Memorandum

To: Kittitas County Public Works
From: Jeff Johnson, P.E.
Date: June 6, 2013
Re: Black Horse Subdivision – Flood Risk Review

Figure 2

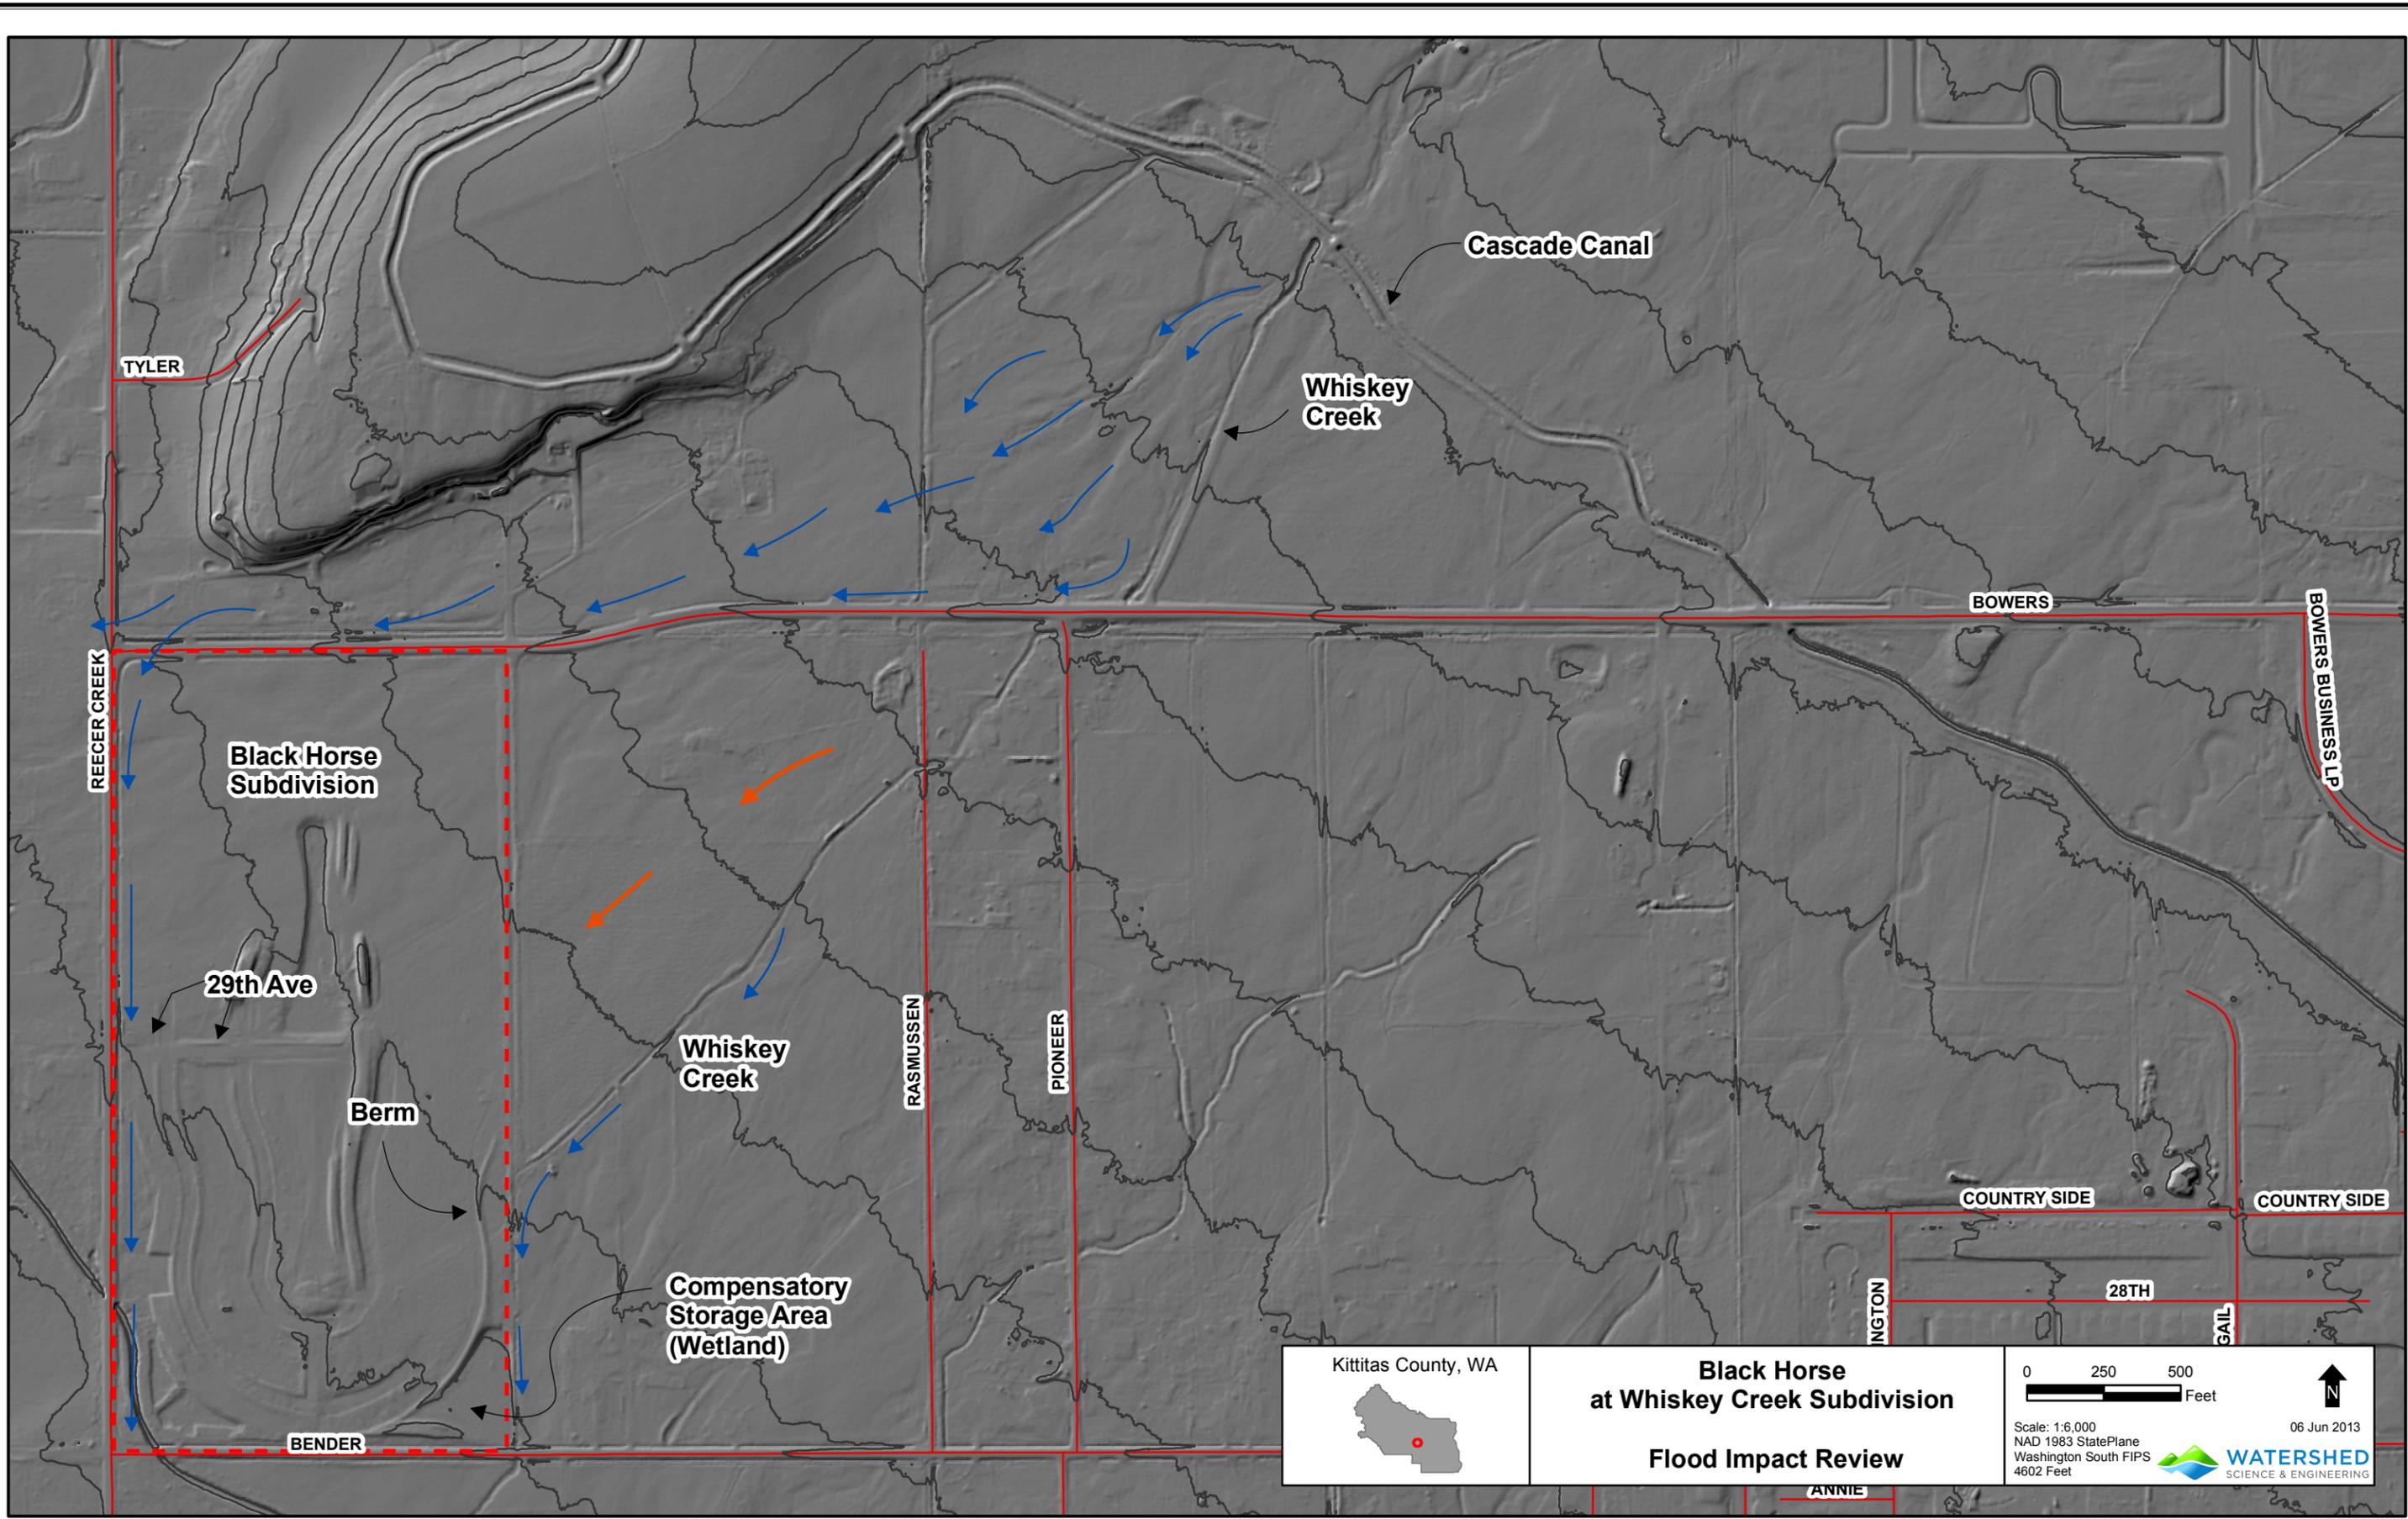
- a. As shown by the blue arrows in Figure 2, it appears that that flood water can leave Whiskey Creek just downstream from the Cascade Irrigation Canal and flow overland to the west, bypassing the Bowers Road Whiskey Creek crossing. This water will eventually be intercepted by the Bowers Road fill and directed west toward the intersection of Bowers and Reecer Creek Roads. At the intersection the water will over top both Reecer Creek Road and Bowers Road. The water that overtops Bowers Road will enter the road side ditch between the development and Reecer Creek Road. The volume of water entering the ditch could be large and may overwhelm the proposed ditch. This could result in flooding of the proposed sediment/detention ponds, 29th Avenue, low lying home lots that border Reecer Creek Road, etc.

5. One additional issue that should be considered is whether flood water can leave Whiskey Creek downstream from Rasmussen Road and flow overland into the northeast portion of the subdivision (see orange arrows in Figure 2).

Based upon the points above, it is our opinion that the flood risk along Reecer Creek Road has not been adequately evaluated. We recommend that a thorough investigation of flood risk be undertaken to determine if design revisions are needed to provide adequate flood conveyance facilities along the subdivision side of Reecer Creek Road. This investigation will need to include a thorough field inspection of potential overflow routes from Whiskey Creek and an assessment of the risk posed by the irrigation canal.
